Project	IEEE 802.16 Broadband Wireless Access Working Group < http://ieee802.org/16 >	
Title	Corrections for the Protocol Stack of Security Layer	
Data Submitted	2005-05-04	
Source(s)	Seokheon Cho Taeyong Lee Jaesun Cha Chulsik Yoon ETRI Yong Chang SAMSUNG Yongjoo Tcha KT Li Rui, Tian Feng ZTE corporation Yigal Eliaspur Intel Corp.	Voice: +82-42-860-5524 Fax: +82-42-861-1966 chosh@etri.re.kr 161, Gajeong-dong, Yuseong-Gu, Daejeon, 305-350, Korea
Re:	IEEE P802.16e/D7	
Abstract	The document contains suggestions on the changes into IEEE 802.16e/D7 that would correct the protocol stack of security layer.	
Purpose	Adoption of proposed changes into P802.16e/D7	
Notice	This document has been prepared to assist IEEE 802.16. It is offered as a basis for discussion and is not binding on the contributing individual(s) or organization(s). The material in this document is subject to change in form and content after further study. The contributor(s) reserve(s) the right to add, amend or withdraw material contained herein.

Corrections for the Protocol Stack of Security Layer

Proposed changes to IEEE 802.16e/D7

Figure 130j- Security sublayer

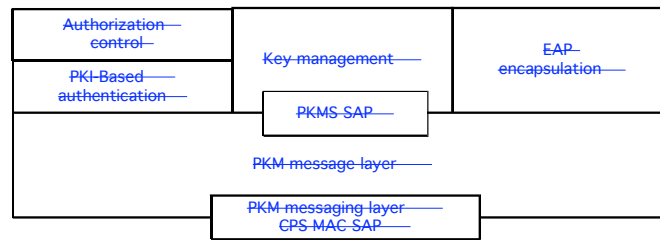
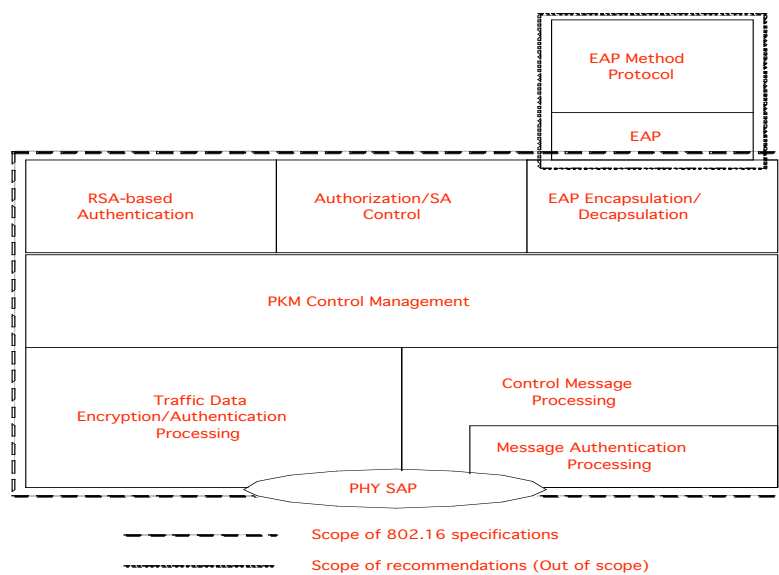
However, the protocol stack doesn't fully support all security sub-functions; it skips some important security components and is wrong-arranged.

The new following security components need to be considered, compared to the existing security protocol stack (Figure 130j and Figure 130k).

- Traffic Data Encryption/Authentication Processing: Stack for processing the traffic data encryption/decryption and authentication as data plane
- Message Authentication Processing: Stack for executing message authentication function as control plane, e.g., HMAC or OMAC
- PKM Control Management: Stack for entirely managing the PKM version 1 and the PKM version 2, and controlling all security components
- Authorization Control: Stack for controlling the authorization key state machine
- SA Control: Stack for controlling multiple traffic encryption key state machines

- Control Message Processing: Stack for processing the PKM-related MAC messages. Since the general MAC messages (e.g., DSA-REQ, DSA-RSP, and so on) are made in the MAC CPS layer, it is reasonable that the function for processing PKM-related MAC message should be executed in the PKM CPS layer.

[Exchange Figure 130j for the following new Figure and Add contents below Figure 130j as follows:]

Figure 130k-Comparison of the Basic and Extended Privacy Layers (Control plane)

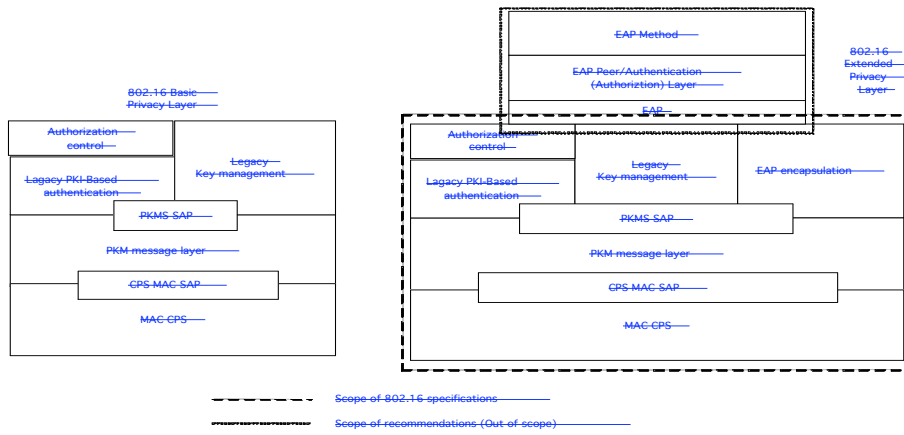
[Modify the sub-clause 7.1.3.2 as follows:] and [Delete Figure 130k]
